UNITED STATES PATENT AND TRADEMARK OFFICE

APPLICATION NO.	FILING DATE	FIRST NAMED INVENTOR	ATTORNEY DOCKET NO.	CONFIRMATION NO.
10/731,340	12/08/2003	Peter C. Anderson	APC01-CIP	3536
24222	7590	05/02/2007		
MAINE & ASMUS 100 MAIN STREET P O BOX 3445 NASHUA, NH 03061-3445			EXAMINER HANSEN, JAMES ORVILLE	
			ART UNIT 3637	PAPER NUMBER
			MAIL DATE 05/02/2007	DELIVERY MODE PAPER

Office Action Summary

DETAILED ACTION

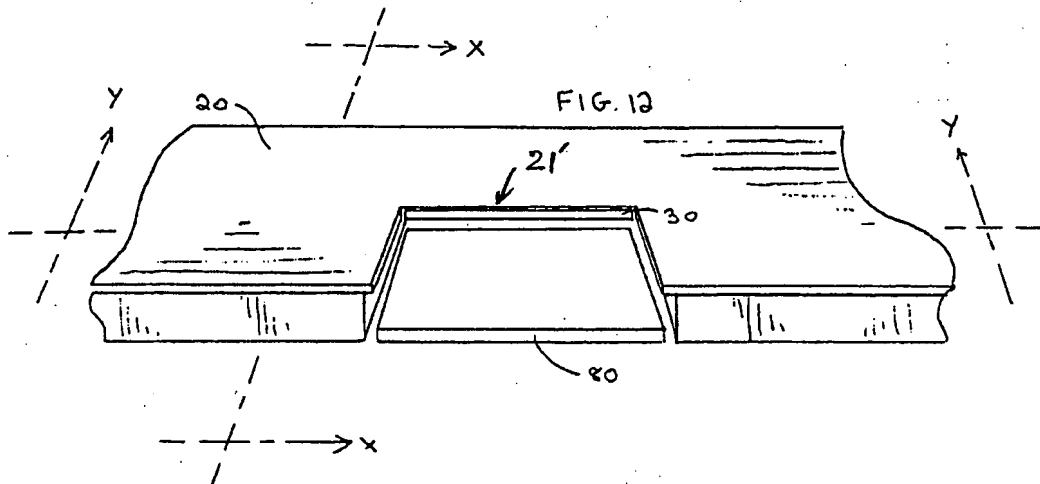
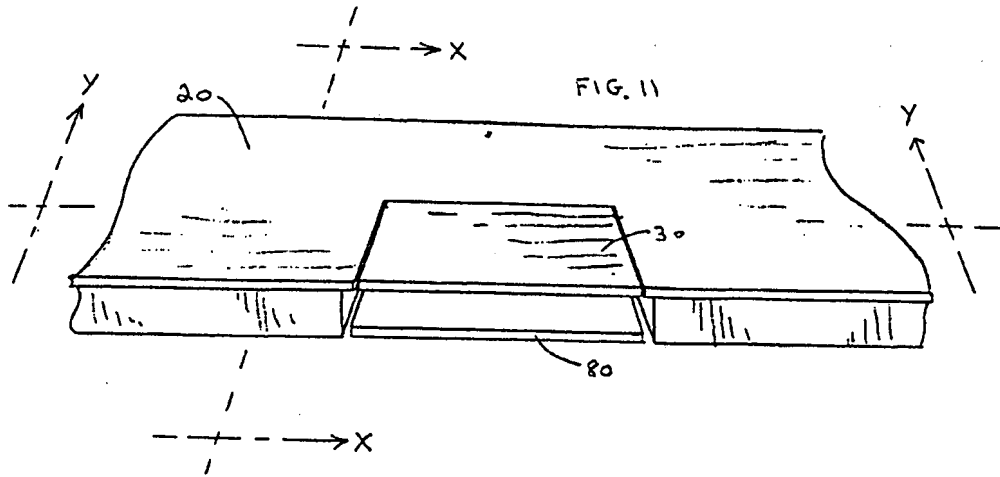
5. The proposed replacement sheet of drawings was received on November 27, 2007. These drawings have not been approved by the examiner since the element labeled "21'" in the drawings is described in the specification as element "20' ". As such, the examiner cannot approve the drawings at this time in the prosecution of the application. Appropriate correction is required.

Not Approved for examination purposes
4/19/07 Jph
